Well Name: R WILSON FED COM	Well Location: T23S / R27E / SEC 22 / NENE / 32.2944583 / -104.17257	County or Parish/State: EDDY / NM
Well Number: 221H	Type of Well: OIL WELL	Allottee or Tribe Name:
Lease Number: NMNM139351	Unit or CA Name:	Unit or CA Number:
US Well Number: 3001557555	Operator: MATADOR PRODUCTION COMPANY

Sundry ID: 2898540

Type of Action: APD Change

OPERATOR'S NAME: MATADOR PRODUCTION COMPANY
WELL NAME & NO.: R WILSON FED COM 137H
APD ID: 10400106506
LOCATION: Section 22, T.23 S., R.27 E. NMP.
COUNTY: Eddy County, New Mexico ▼

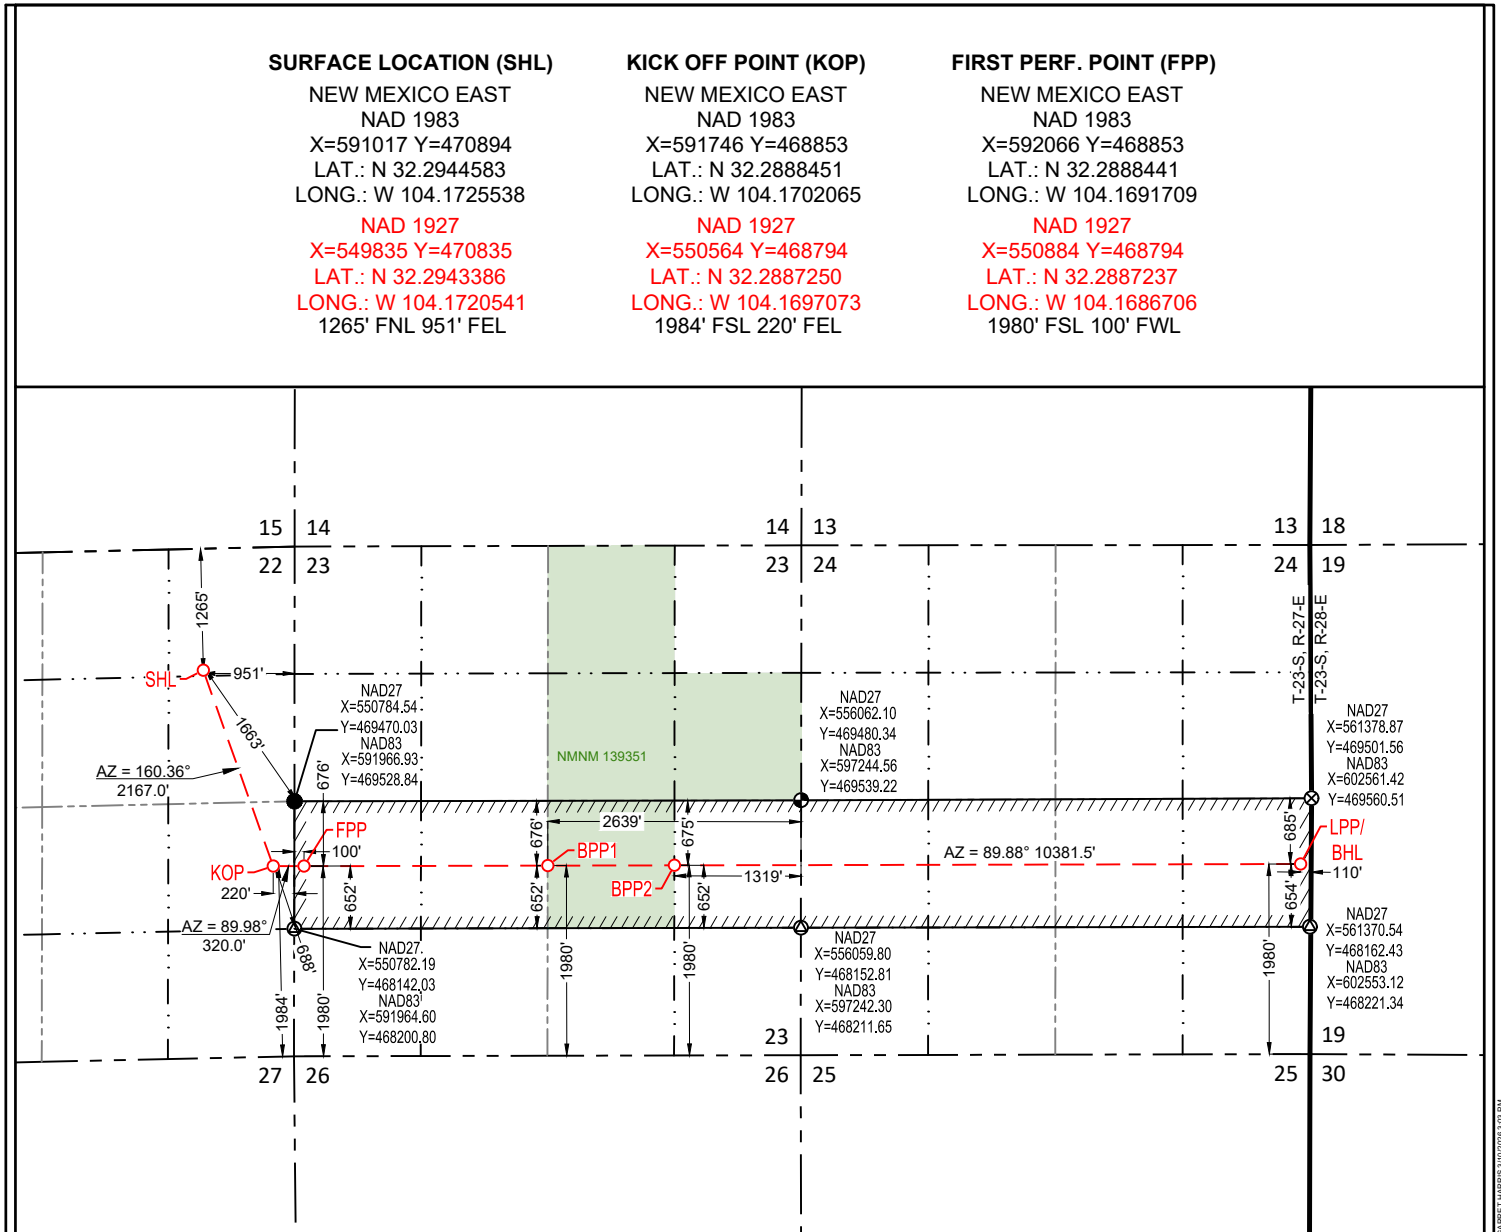
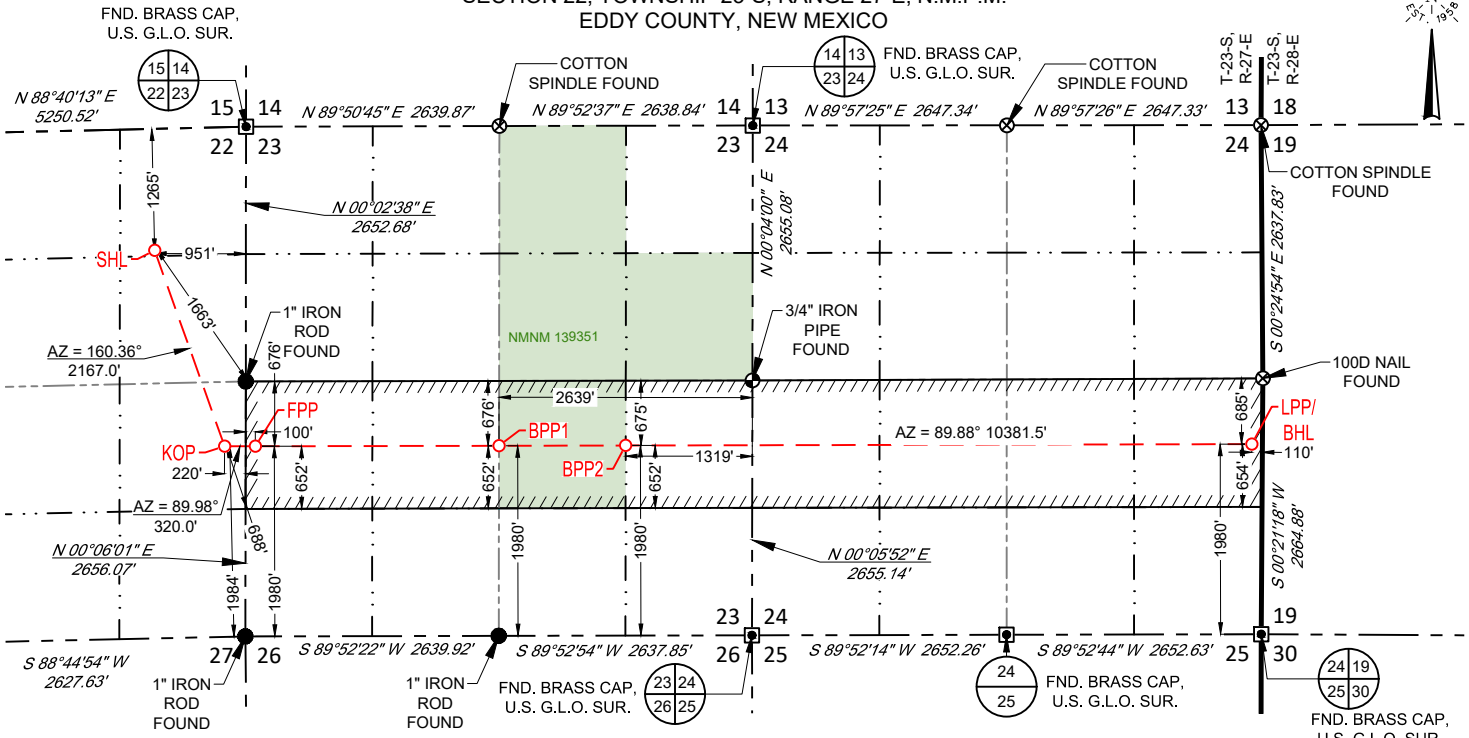
- Change well name from R Wilson Fed Com 221H to R Wilson Fed Com 137H
- Change target TVD from 9950' to 8985'
- Change well SHL from 1265' FNL & 956' FEL section 22 to 1265' FNL & 951' FEL section 22
- Change well BHL from 990' FNL & 340' FEL section 24 to 1980' FSL & 110' FEL section 24
- Option to drill intermediate hole size of 8-3/4" OH
- Option to run intermediate casing type of 7-5/8" MO-FXL
- Option to perform a bradenhead squeeze on the intermediate string. The top of the primary tail slurry will be pumped to the top of the **Brushy Canyon**, bradenhead squeeze will be performed offline to fill the annulus to surface.
